### Re: Comments on the Draft Butte Priority Soils Operable Unit (BPSOU) Buffalo Gulch 60 Percent Design (dated December 9, 2022)

July 24, 2023

Mr. Josh Bryson  
Liability Manager  
Atlantic Richfield Company  
317 Anaconda Road  
Butte, MT 59701

**Re: Comments on the Draft Butte Priority Soils Operable Unit (BPSOU) Buffalo Gulch 60 Percent Design (dated December 9, 2022)**

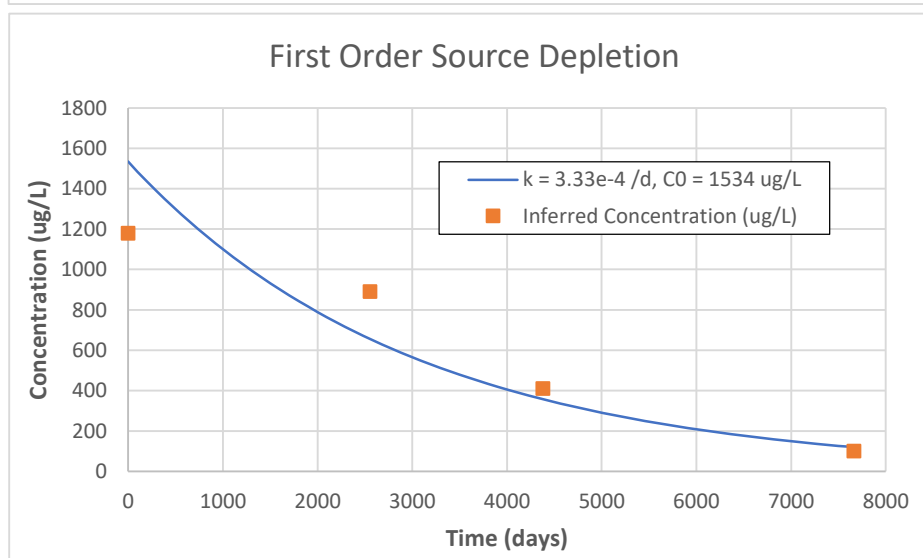
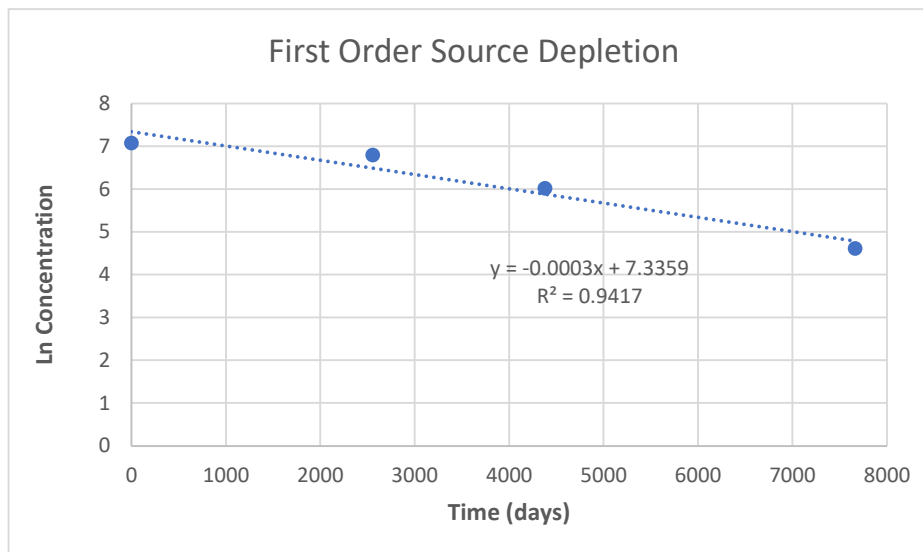
156. Section 2.3.4 Main Channel, Bank Lines, and Cross-Sections – Outlet Model - The text states, “These bank lines denote the transition from bankfull flow to overbank flow, conditions which necessitate different roughness coefficients due to the dissimilarity of the channel surface.” The USACE suggests these channel forming discharges: 2-year flood for perennial streams, 10-year flood for ephemeral streams, bankfull discharge, or effective bed load sediment carrying discharge.

Ensure that bank lines/points were drawn appropriately according to USACE recommendations because, as was said, the location of roughness change plays a key role in calculated discharges.
